RE: As-builts fro Hoist House and Upper No. 2 Canyon Sediment Pond NOV 93-32-3-8 #2 of 8, Sunnyside Coal Company, Sunnyside Mine, ACT/007/007, File #2, Carbon County, Utah

Project: UPPER NO. 2 CANYON SEDIMENT POND
AS-BUILT DESIGN

Re: Inadequate Ponds, Sunnyside Coal Company, Sunnyside Mine, ACT/007/007-93CC,
Folder #3, Carbon County, Utah

TO: Joe Helfrich, Compliance Supervisor *JGH*
FROM: Wayne H. Western, Reclamation Engineer *WHW*
DATE: July 11, 1994
RE: Upper No. 2 Canyon and Hoist House Sediment Pond Modifications,
Sunnyside Coal Company, Sunnyside Mine, ACT/007/007, Folder #2, Carbon
County, Utah

PLAN VIEW
UPPER NO. 2 SEDIMENT POND
SCALE 1" = 50'

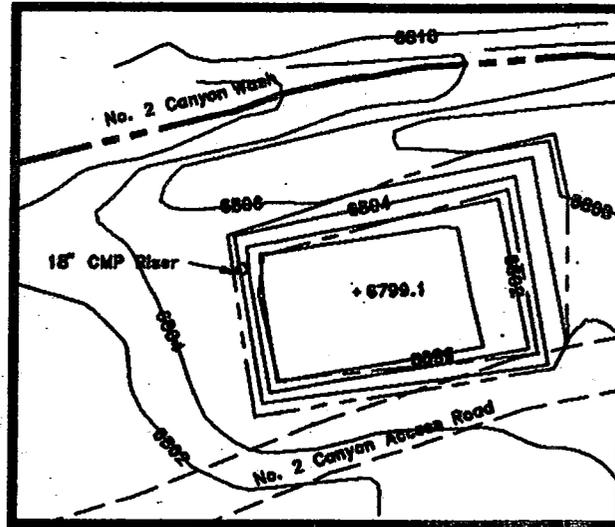
The Division has examined the as-built drawing for the Hoist House and Upper No. 2 Canyon sediment ponds at the Sunnyside Mine. Both ponds have volumes that meet or exceed design specifications.

The Upper No. 2 Canyon pond is required to have a volume of 0.26 acre-feet after sediment cleanout; the as-built shows the pond has a volume of 0.360 acre-feet. The volume to the emergency spillway shown on the as-built to be 0.237 acre-feet, while the requirement is 0.19 acre-feet.

8/29
Joe/Daron -
These are the as-builts.
RAM
ACR/003/003 #5
Copy RAM
93CC
